7.2 Reactor Protection (Trip) System (RPS)—Instrumentation and Controls

The information in this section of the reference ABWR DCD, including all subsections, tables and figures, is incorporated by reference with the following departures and supplements.

STD DEP T1 2.3-1 (Table 7.2-1, 7.2-2, Figures 7.2-2, 7.2-6, 7.2-9, 7.2-10)

STD DEP T1 3.4-1 (Figures 7.2-2, 7.2-9, 7.2-10)

Figure 7.2-2 Reactor Protection System Equipment Arrangement (From Sensors Through Trip Actuators)

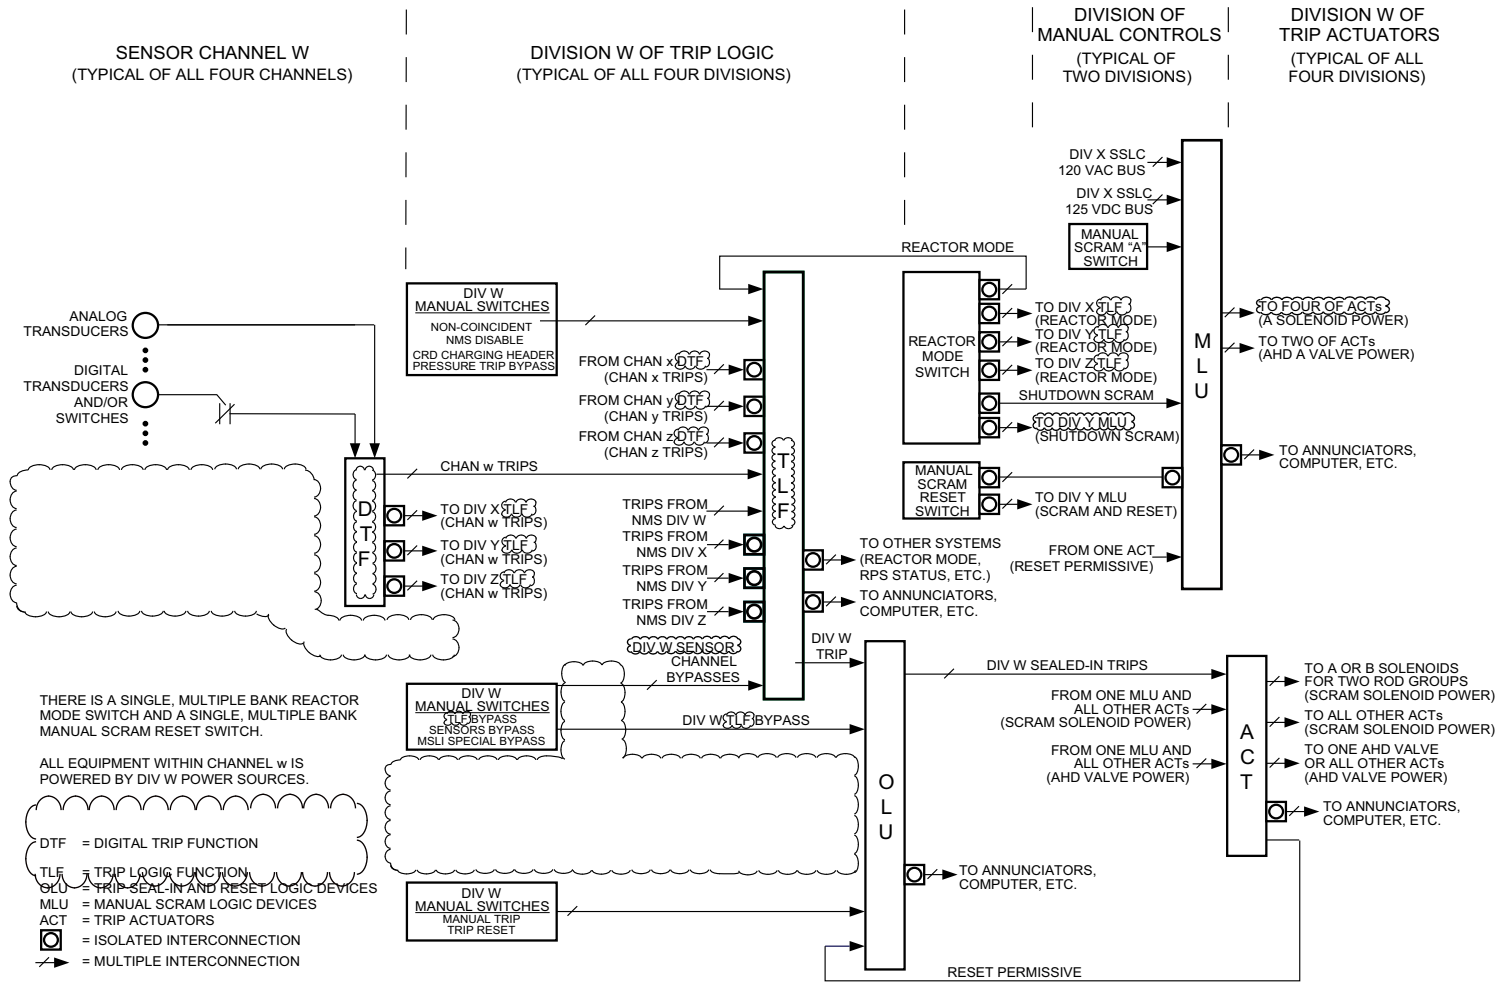
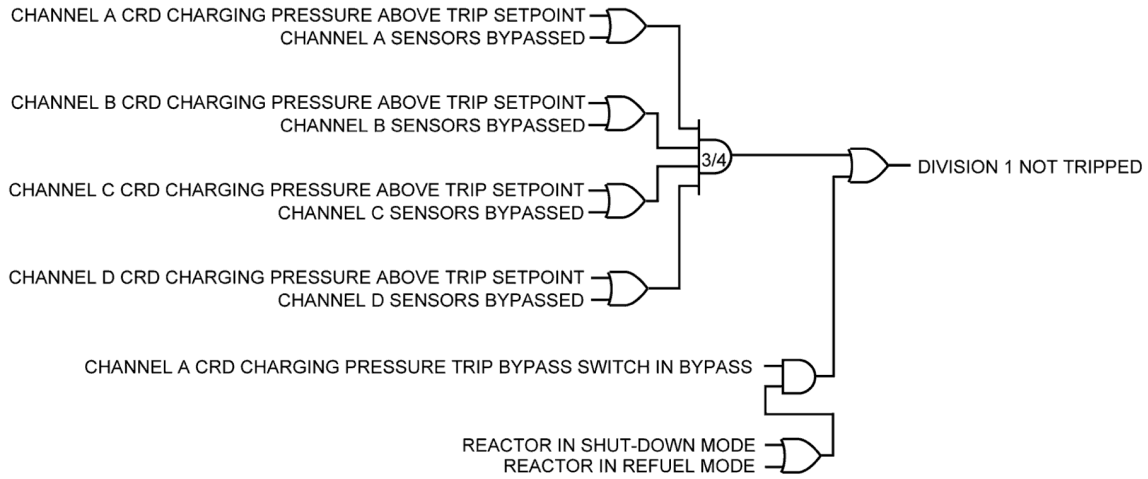
The RPS equipment is divided into four redundant divisions of sensor (instrument) channels, trip logics and trip actuators, and two divisions of manual scram controls and scram logic circuitry. The sensor channels, divisions of trip logics, divisions of trip actuators and associated portions of the divisions of scram logic circuitry together constitute the RPS scram and air header dump (backup scram) automatic initiation logic. The divisions of manual scram controls and associated portions of the divisions of scram logic circuitry together constitute the RPS scram and air header dump manual initiation logic. The automatic and manual scram initiation logics are independent of each other. RPS equipment arrangement is shown in Figure 7.2-2.

Equipment within a sensor channel includes primarily sensors (transducers or switches), ~~multiplexers and digital trip modules (DTMs)~~ trip functions (DTFs). The sensors within each channel monitor plant variables (Subsection 7.2.1.1.4.2) ~~and send either analog or discrete output to remote multiplexer units (RMUs) within the associated division of Essential Multiplexing System (EMS) the DTF.~~ Each division of the EMS performs analog to digital conversion on analog signals and sends the digital or digitized analog output values of all monitored variables to the DTF within the associated RPS sensor channel. The ~~DTM DTF~~ in each sensor channel compares individual monitored variable values with trip setpoint values and for each variable sends a separate, discrete (trip/no trip) output signal to all four divisions of trip logics.

Equipment within a division of trip logic includes primarily manual switches, ~~bypass units (BPUs)~~ bypass interlock functions, trip logic units functions (TLUs/TLFs) and output logic units (OLUs). The various manual switches provide the operator means to modify the RPS trip logic for special operation, maintenance, testing and reset. The ~~BPUs~~ bypass interlock functions enforce restrictions on bypassing multiple divisions of related functions. The bypass interlock functions perform bypass and interlock logic for the channel sensors bypass, main steamline isolation trip special bypass and division trip logic unit bypass. These three bypasses are all manually initiated through individual

~~keylock bypass~~ switches within each of the four divisions. Each ~~BPU bypass switch~~ sends a separate bypass signal for all four channels to the ~~TLUTLE~~ in the same division for channel sensors bypass and MSL isolation trip special bypass. Each ~~BPU bypass switch~~ sends the ~~TLUTLE~~ bypass signal to the OLU in the same division.

Figure 7.2-6 Division 1 Trip Logic

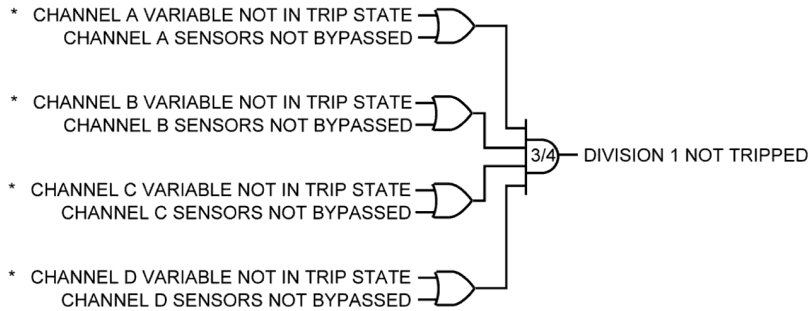
(4) ~~Process Radiation Monitoring (PRM) System (Figure 7.2-6)~~ Not Used

~~*High Main Steamline Radiation Trip (Figure 7.2-6)*~~

~~*A high main steamline radiation trip will occur in each division of trip logic when a main steamline radiation trip condition exists in any two or more unbypassed sensor channels. There are no operating bypasses associated with this trip function.*~~
